Post-examination Comments

**V. C. SUMMER EXAM
50-395/2004-301**

Licensee Submitted Post-Examination Comments

Subject: VIRGIL C. SUMMER NUCLEAR STATION
DOCKET NO. 50/395
OPERATING LICENSE NO. NPF-12
POST EXAM COMMENTS FOR THE RO EXAM
ADMINISTERED APRIL 28, 2004

10 GPM Pzr Steam Space Leak

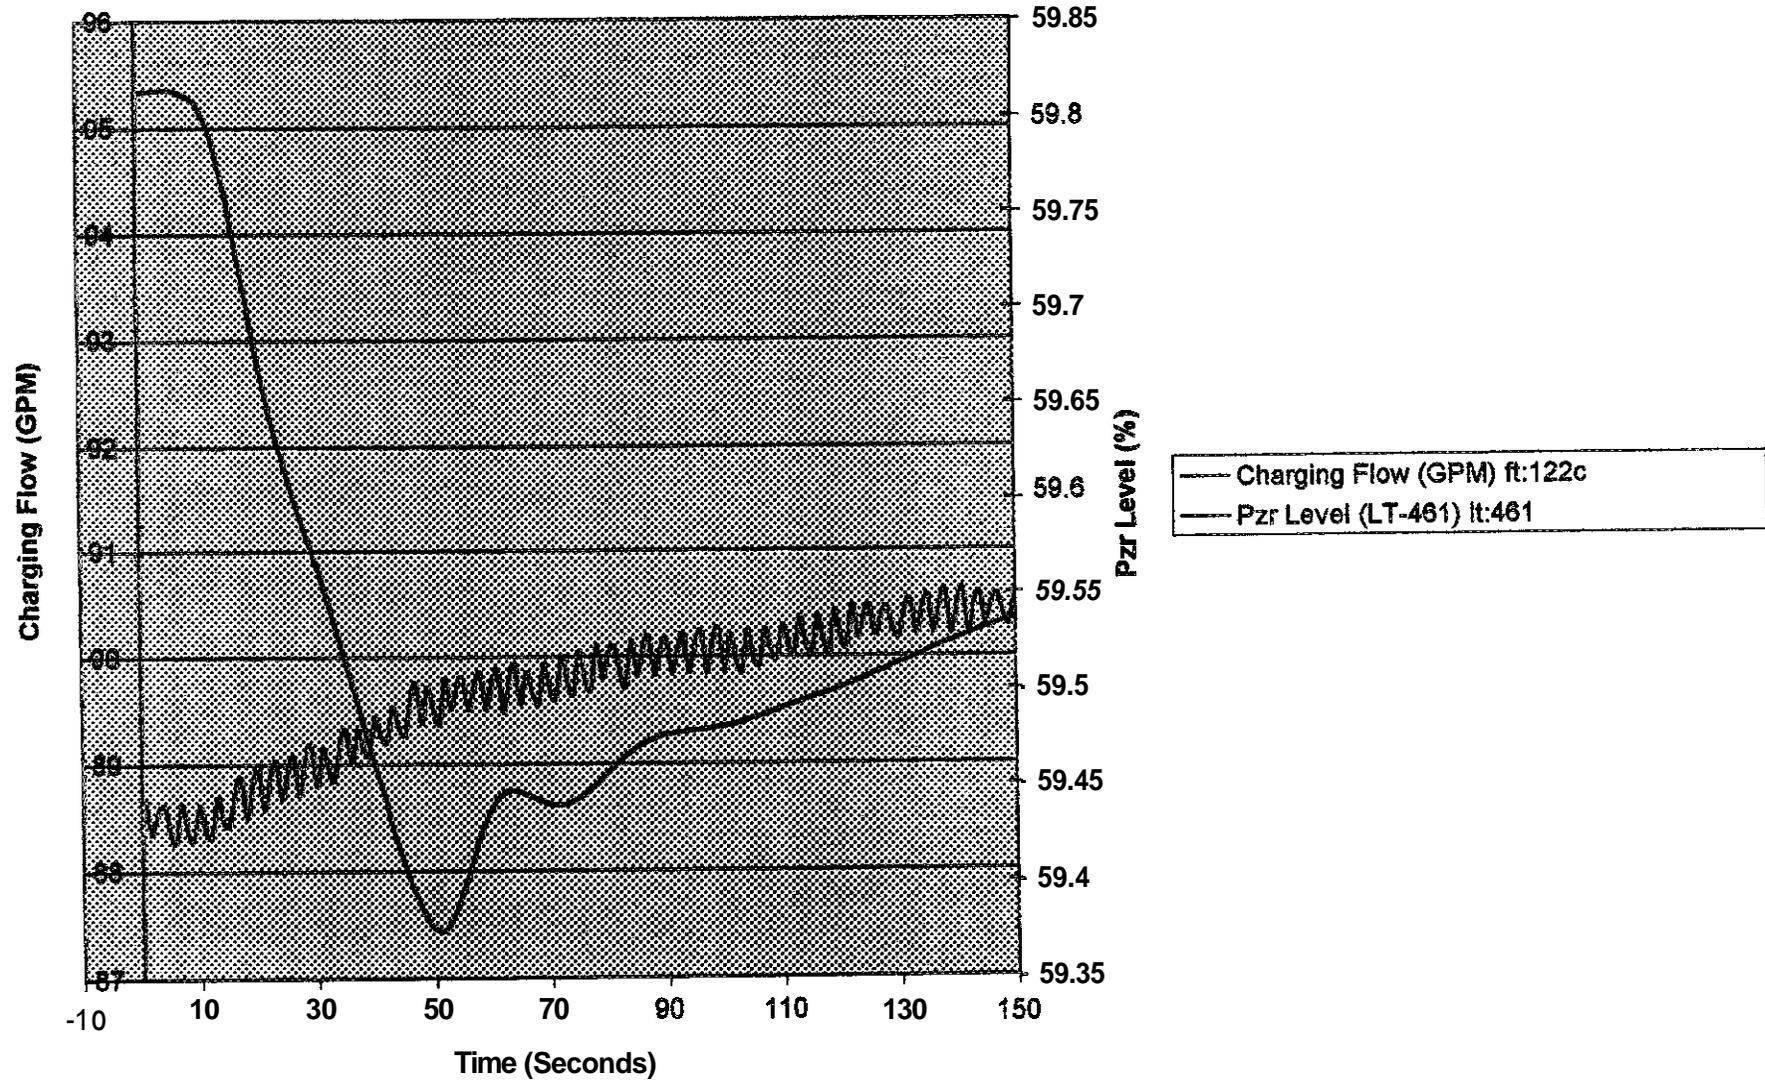
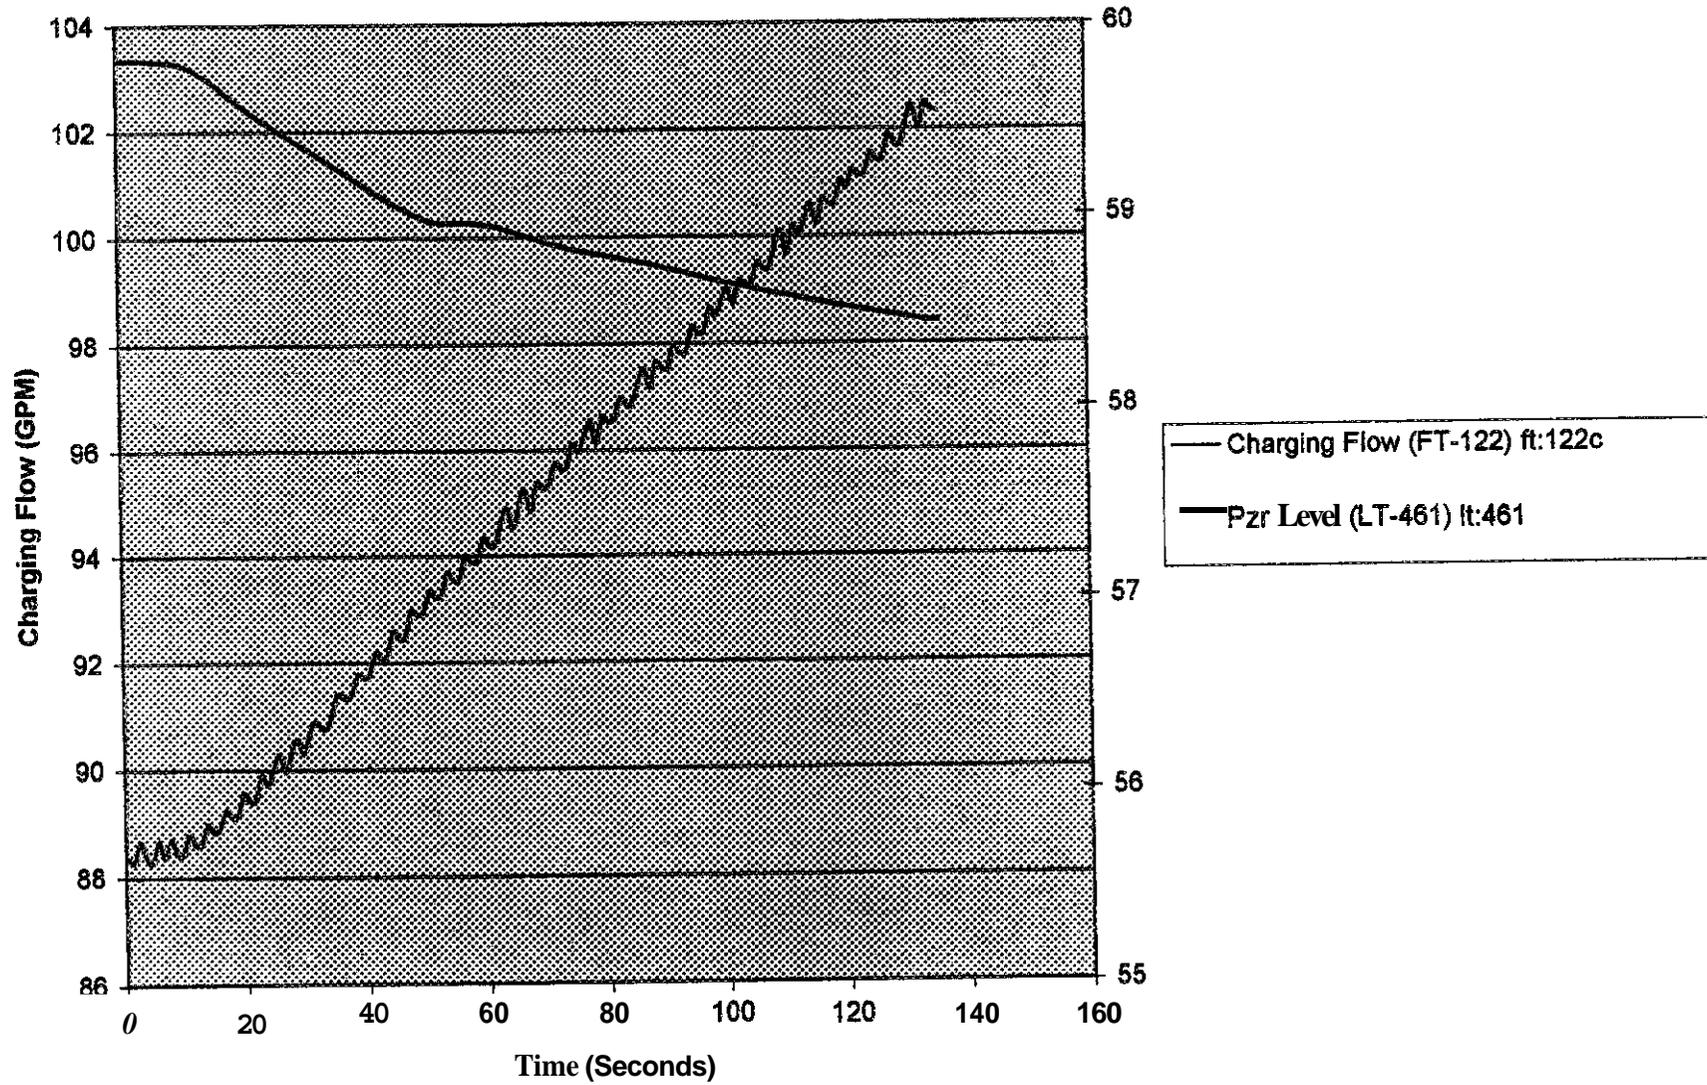
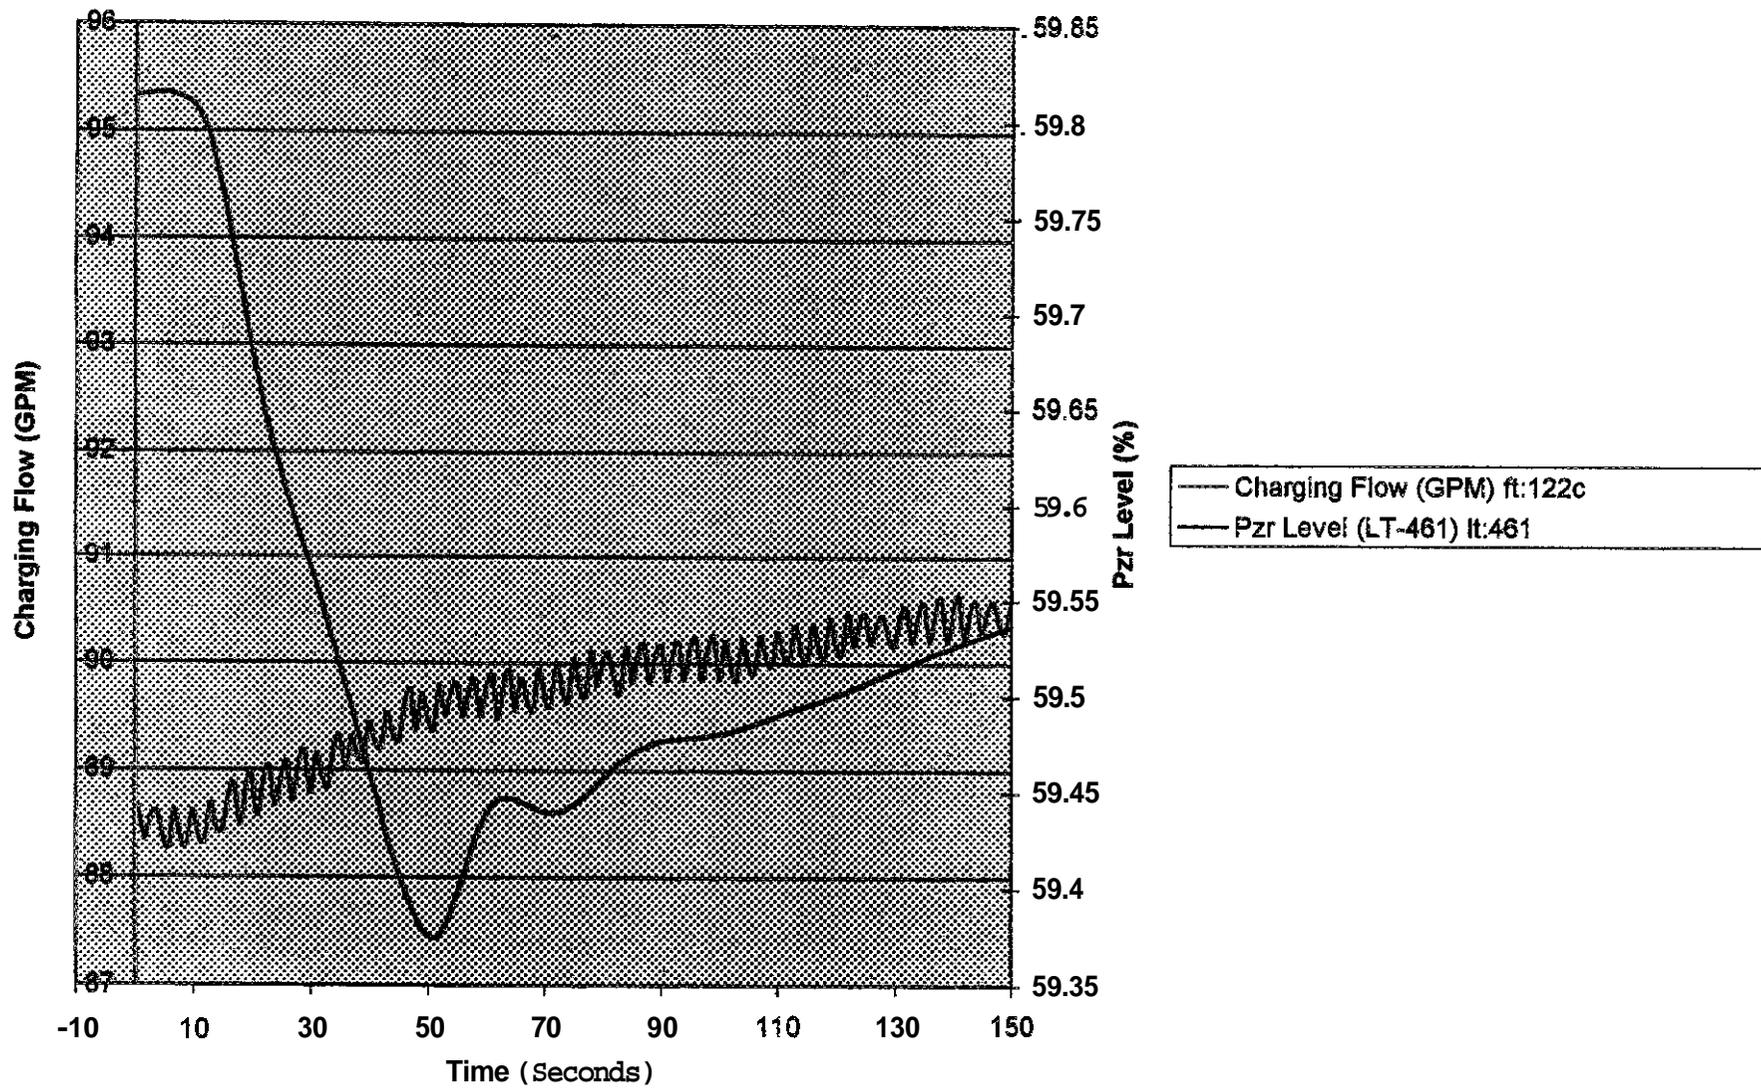
Change the correct answer from B to D

The given conditions provide the examinee with a reference leg break somewhere downstream of the condensing pot for LT 460. The examinees with the correct understanding of how a D/P detector works, based on fundamentals, **determine** that level would rise. Only answers B and D provide that option.

Considering charging flow control valve FCV 122 and how it will respond, charging flow **control** will send a decreasing signal **in** response to the actual **PZR** level rise (LT 461), or an increasing signal **in** response to an actual **PZR** level fall. If the leak is large enough, then actual indicated charging flow will increase in **response** to the system pressure drop **as well, as** the affect of decreasing system pressure is a lower backpressure ~~for~~ the charging pump to **pump** against. It is difficult to predict what would happen to charging flow based on this **type** theoretical approach, yet in no case will charging flow act in the **same** direction as **PZR** level change as described in answer B.

As no specific **size** was specified **in** the question, we tried **two scenarios** on the simulator in **an attempt to** estimate what we thought might be seen with a reference leg leak on a level detector downstream of the condensing pot.

For a very **small** steam space leak (we used **10 GPM**), actual **PZR** level fell, **as well as** charging flow increasing in response to the leak. It was clear that there was **not** enough **mass** or pressure lost to cause any appreciable change in reference leg pressure on the controlling channel (**in this** case, LT 461), and therefore indicated **PZR** level goes down solely in response to the mass loss. Charging flow will increase in **response** to the **PZR** level decrease, and will continue to **rise** until charging flow matches and then exceeds **break** flow, and **PZR** level returns to program **This** would support **answer D**.

We also ran the steam space leak at **75 GPM**. Likewise, the leak was not large enough to cause a **flash** or large decrease in **reference** leg pressure for the controlling channel D/P level detector, so the indicated **PZR** level fell continuously, and charging flow rose continuously, until the RCS **pressure** decreased to the SI set point and a Rx. Trip/ SI occurred. **This** size leak also supports **answer D**

Additionally, **PZR** backup heaters will energize **as** RCS pressure **lowers** to below 2210 **PSIG**.

Answer B is incorrect, regardless of whether or not the examinee considered this **as a** BZR steam space LOCA, where charging flow and **actual PZR** level would **both rise**, or if they took the **more** conservative approach with a **smaller** leak rate and determined that charging flow would increase, while **actual pressurizer** level decreased. Answer B cannot be correct, **as** charging flow cannot fail in response to **an** actual pressurizer level fall, no matter what circumstances the examinee considered.

Fig. 23

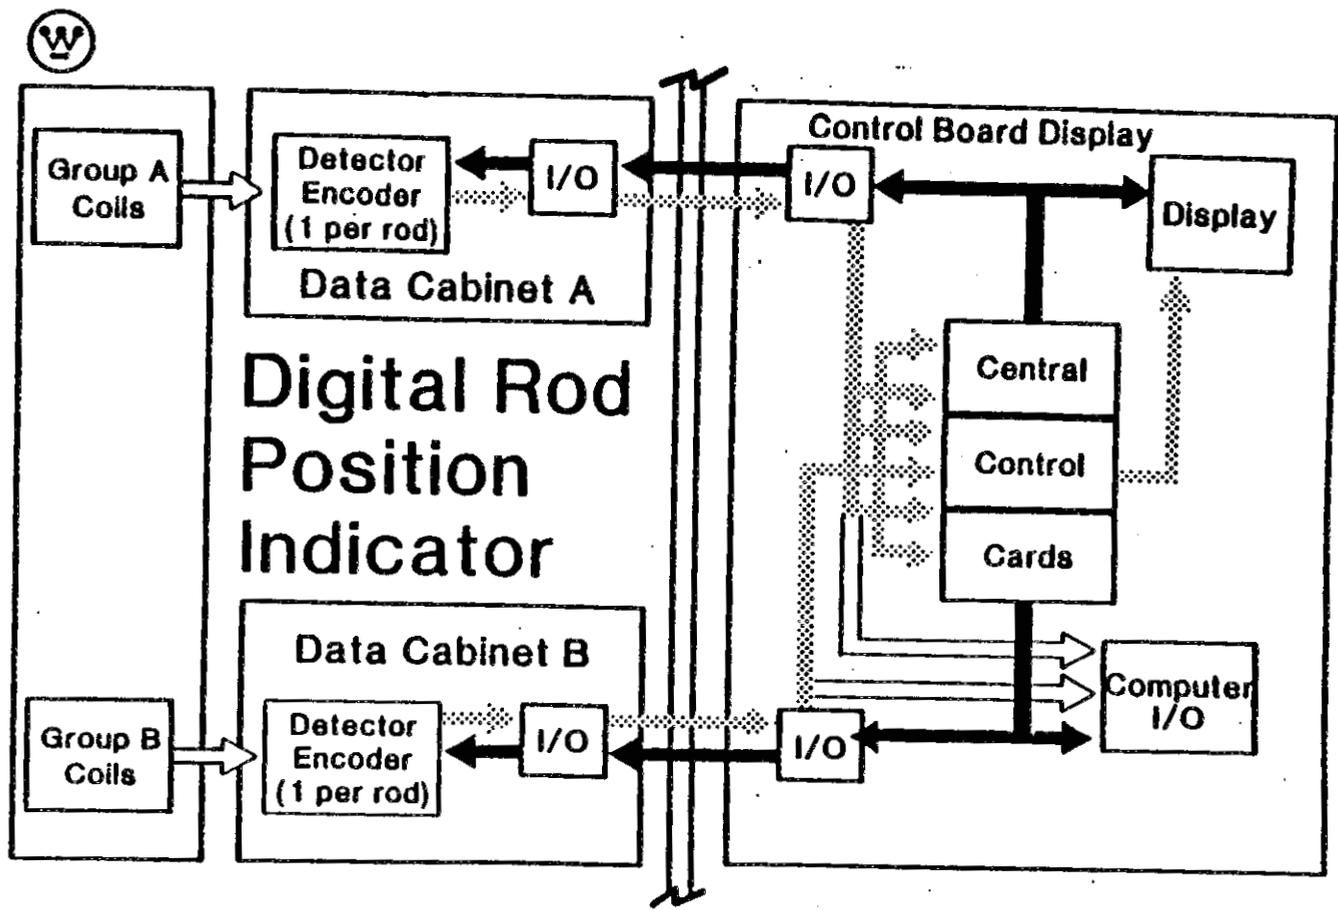
Accept either choice C or D

Answer D *is* taken directly from the list of probably causes outlined in the Annunciator Response Procedure for XCP 620 2-5 "CMPTR ROD DEV."

Refer *to* the attached Figure 2-3 from the Westinghouse DRPI technical manual. The DRPI cabinets receive a signal from each individual rod *as* to its position. The signal is then sent to the control board display I/O card, which is in turn sent to the plant computer (IPCS) I/O card and compared to expected rod position based on demand. **If** a discrepancy exists **at** >12 steps, computer point Y2001C generates an alarm on XCP 620, window 2-5, CMPTR ROD DEV. The ARP lists IPCS computer failure (answer D) as a probable cause, along with three other possibilities.

However this *is* not an all-inclusive list of malfunctions that could cause a computer rod deviation. In discussing the distracters with Rod Steffy, a former Westinghouse rod control system engineer and **current** I&C supervisor at VC Summer, about how DRPI and **the** IPCS interfaced, Rod indicated there were numerous ways that both DRPI data cabinets could either fail *or* create an error, as indicated in answer C, thereby causing a computer rod deviation alarm to be generated by the IPCS plant computer.

Figure GS2.5

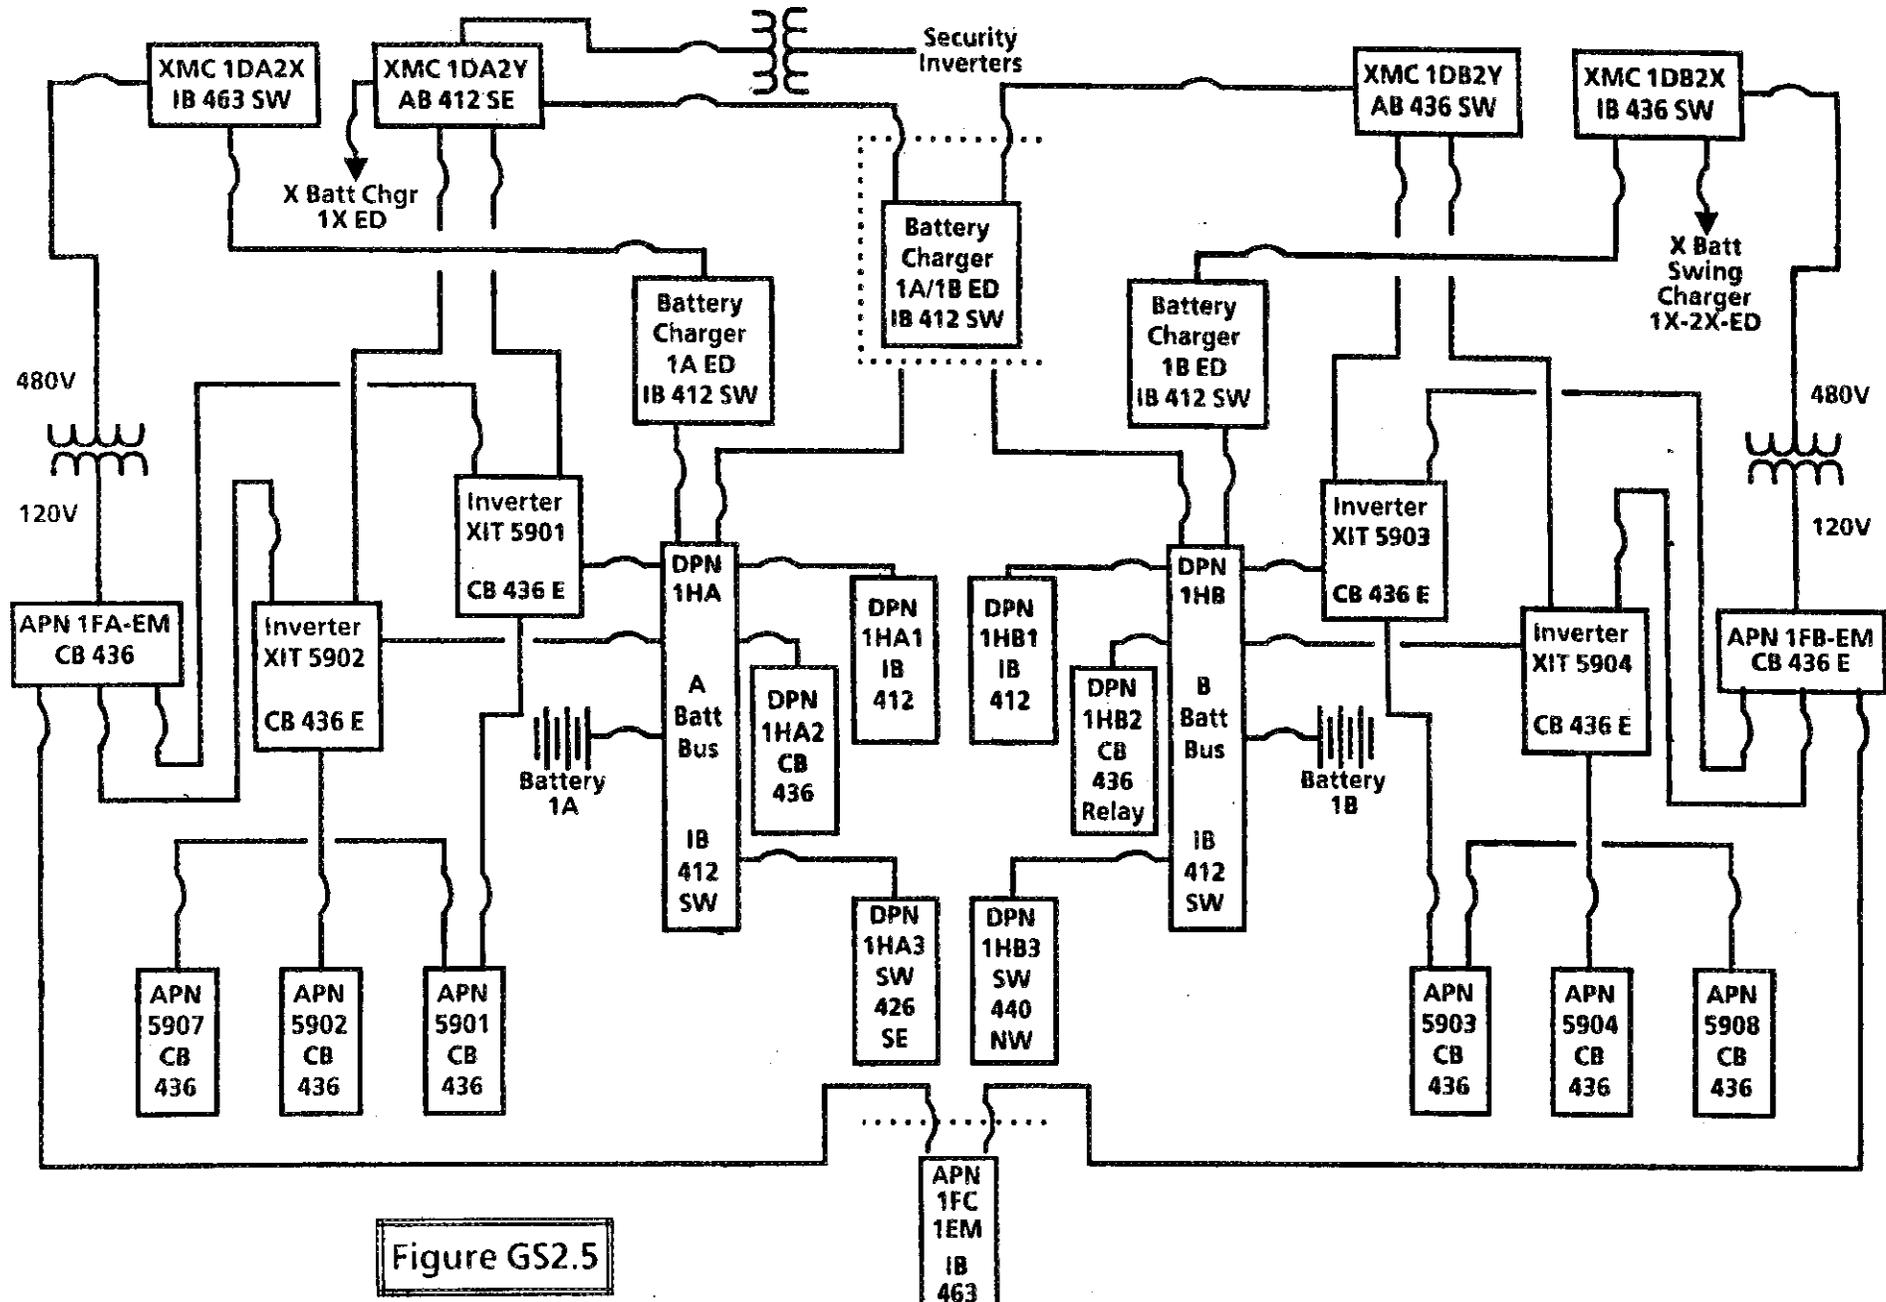
Accept either choice C. or D.

The given conditions have inverter XIT-5901 undergoing maintenance; therefore, APN-5901 is being powered from APN-1FA. The question stipulates that the feeder breaker to APN-1FA then trips, de-energizing APN-1FA.

Since an undervoltage condition on the vital busses, IDA or IDB is not stipulated, the ESFLS on Train B will not be actuated. For the same reason, neither A Train nor B Train running equipment will be affected. This makes the first part of Choices C. & D. correct.

With APN-1FA supplying APN-5901, power to the A Train ESFLS is lost when the normal feeder breaker to APN-1FA trips. Since the second part of Choices C. & D. does not specify which Train of ESFLS is disabled, the second part would be correct since A Train is disabled. Said another way, the second part of Choice D. would only be *incorrect* if it referred specifically to B Train ESFLS.
